Point A Hotel

Kings Cross

Design & Access Statement

Job No: 3949
Doc ref: F:\ADMIN\3900 SERIES\3949\E\DESIGN & ACCESS
STATEMENT.DOCX
Revision C
Date: 23/04/2018

fig. 2 – amended fifth floor guestrooms.

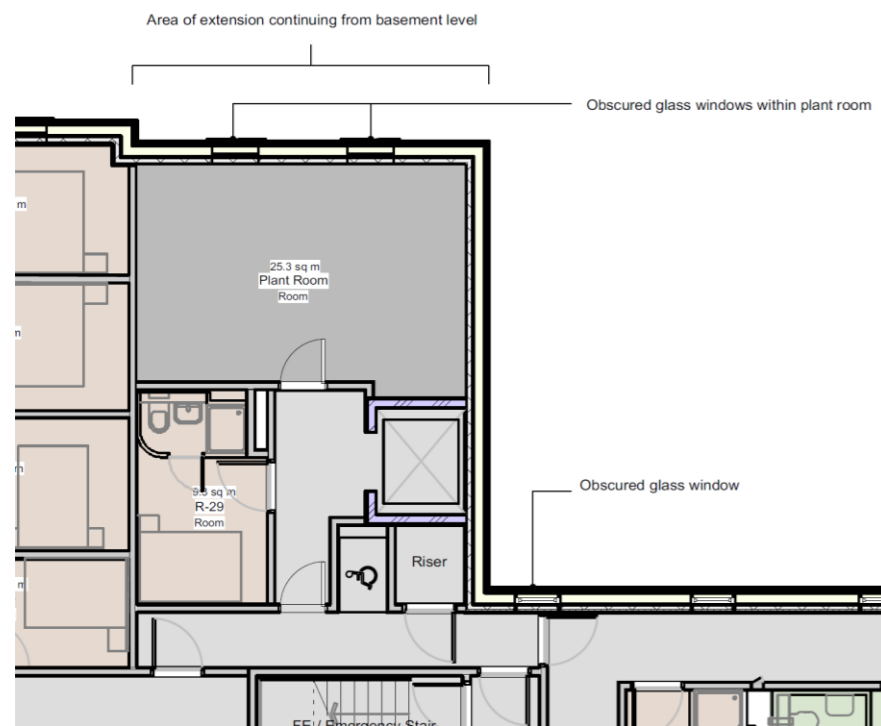
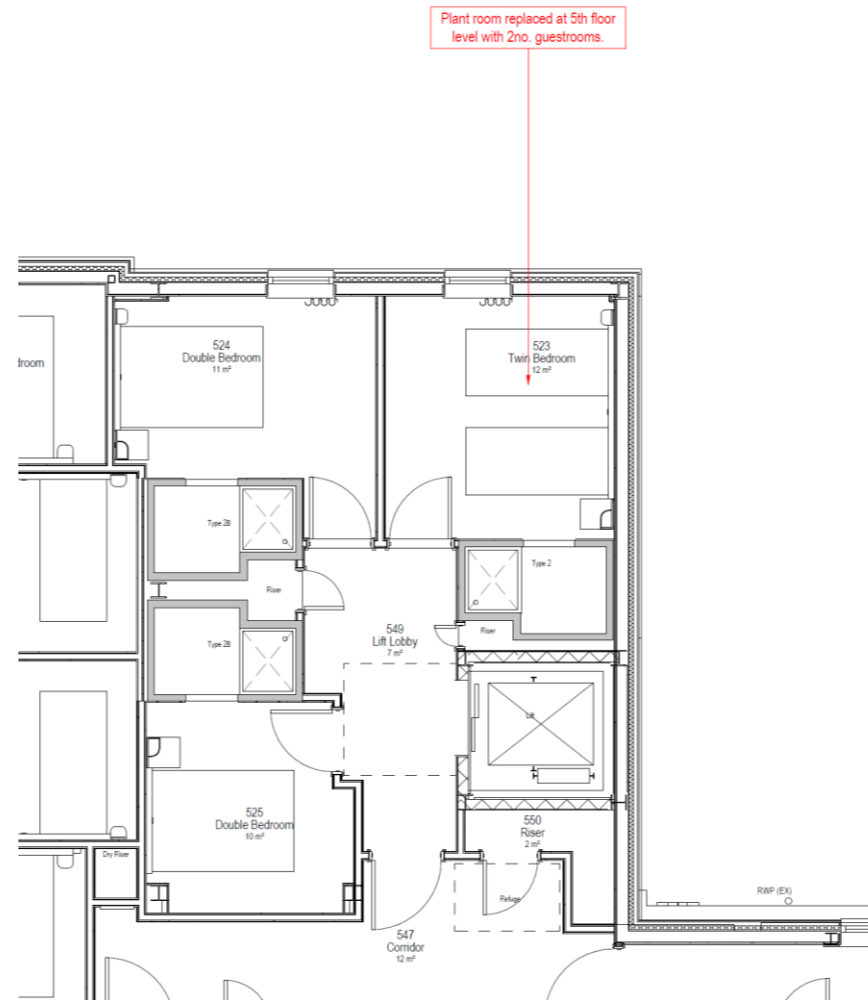
The detailed design for the M&E identified the proposed enclosed plant at fifth floor level, see fig. 1 was obsolete, therefore 2no. guestrooms have been included. The 2no. obscured windows will be replaced with vision windows, see fig.2. These additional two rooms do not increase the total hotel inventory as during the detailed design two rooms were taken out to accommodate additional storage requirements and inclusions of an ironing room.

fig. 4 – part elevation of proposals.

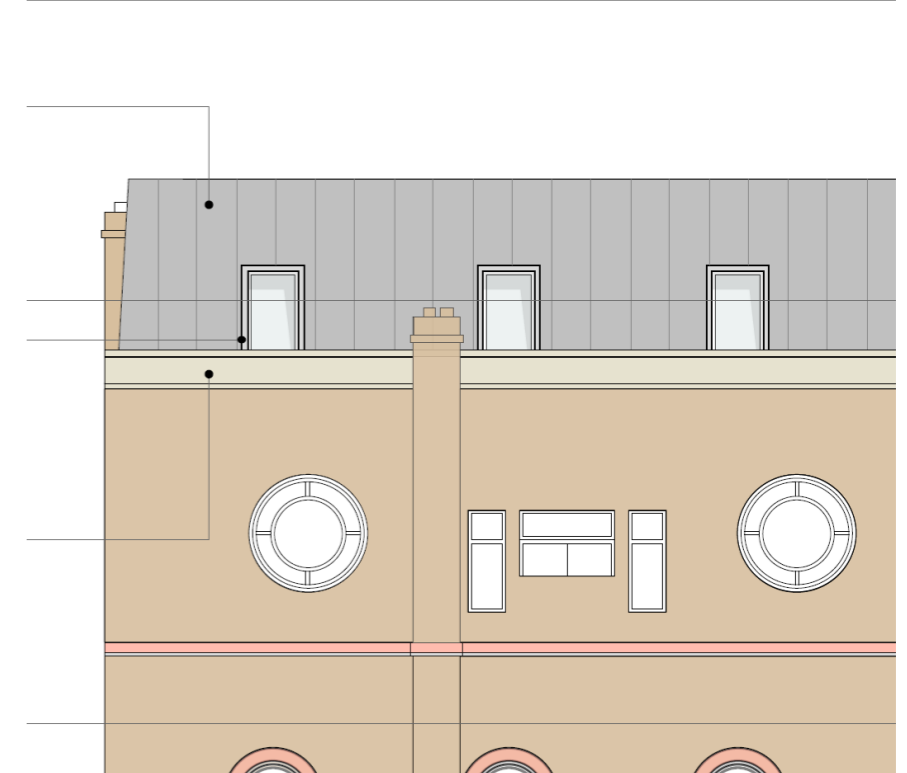
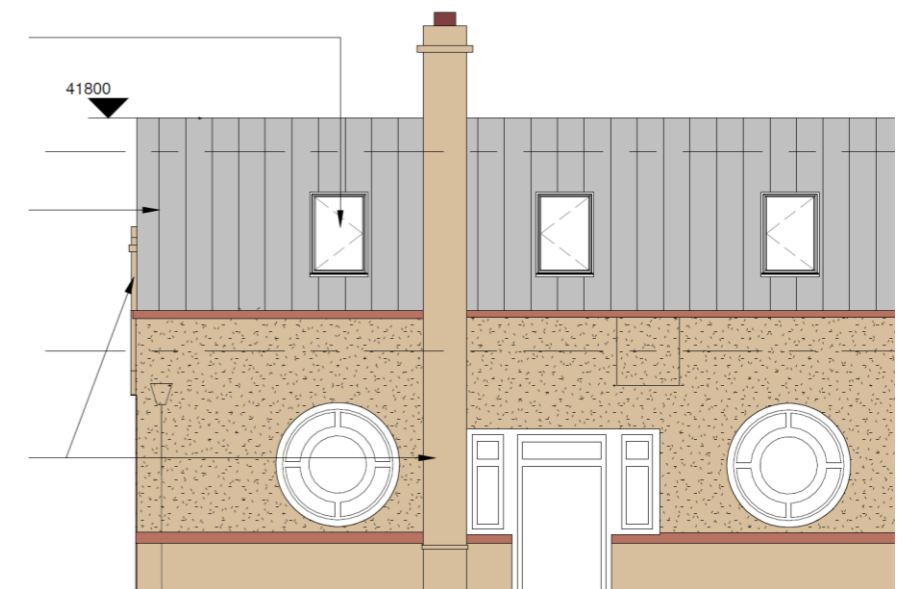
To accommodate opening windows at 5th floor level, under the requirements for boiler extraction, we are seeking approval to extend the existing boiler flue and chimney. Fig. 3 indicates the approved elevation, fig. 4 indicates proposals.

Agreement is sought to amend the gable elevation from the mansard arrangement in fig. 3 to a vertical façade, still utilising the zinc cladding as indicated in fig.4. The purpose of this change is to accommodate the accessible guestrooms within a confined footprint due to the amended fire escape stair as noted in 2.2.1.

fig. 6, proposed elevation.

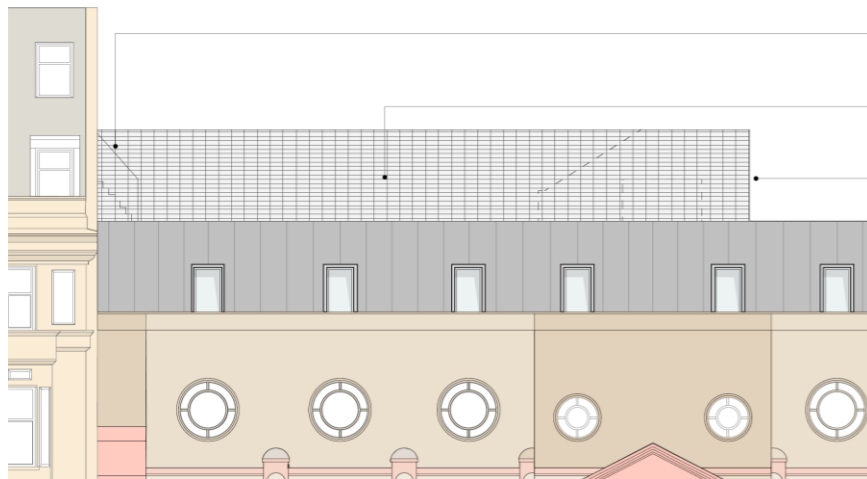
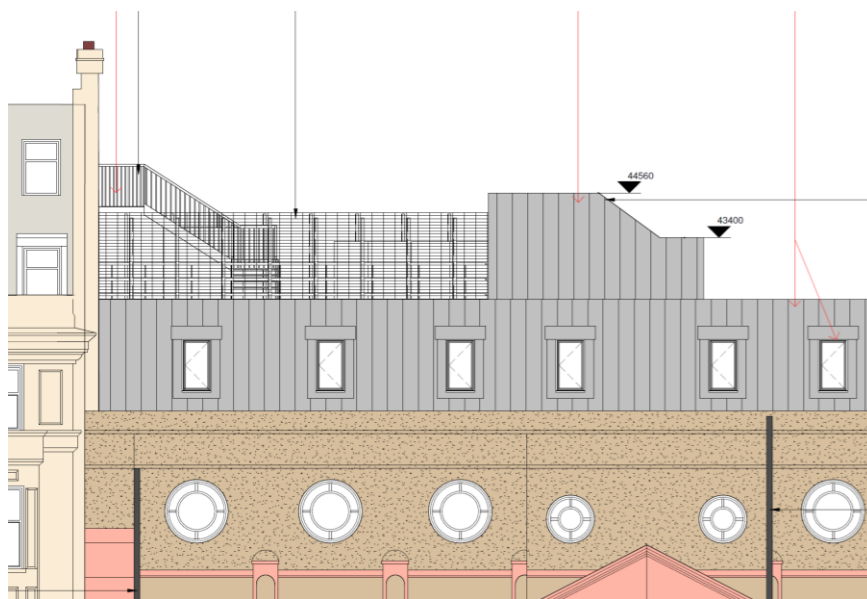
During the detailed design and in consultation with the Building Control, concerns were raised regarding escape from the existing 4th and proposed 5th floor levels. The concerns were in relation to the passing over the head of a stair to access alternative means of escape. To overcome these, the existing stair from 4th to 5th have been removed and reconfigured. The impact at roof level is the pitch to the stair enclosure has been mirrored and linked to the lift overrun. Fig 5 indicates the approved scheme, fig. 6 indicates the proposed scheme.

fig. 8 – proposed roof plan

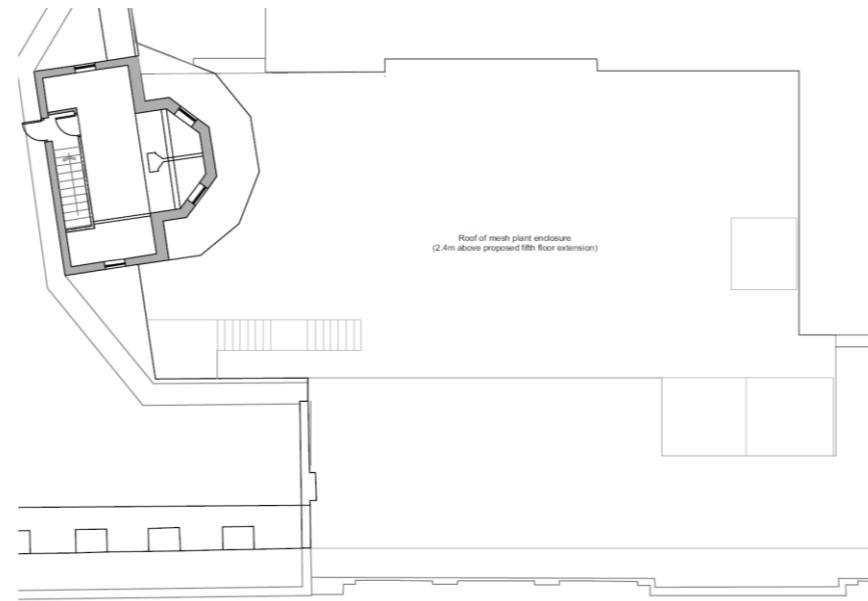
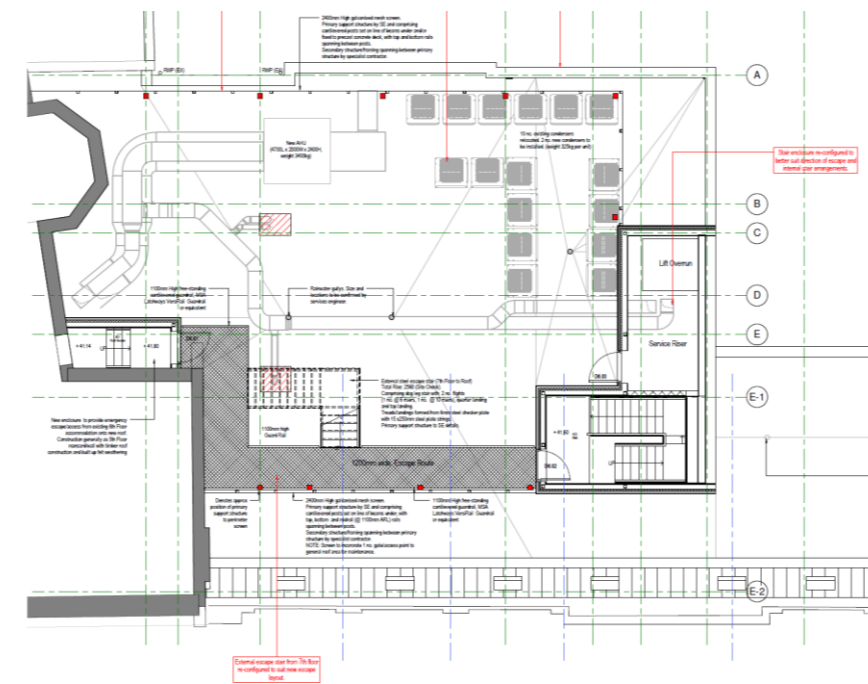
Amendments to the plant enclosure are sought to bring forward the line of enclosure to assist with revised escape stair from 6th & 7th floor levels. The line of the proposed enclosure is to run along the face of the escape stair enclosure as indicated in fig. 7-8.
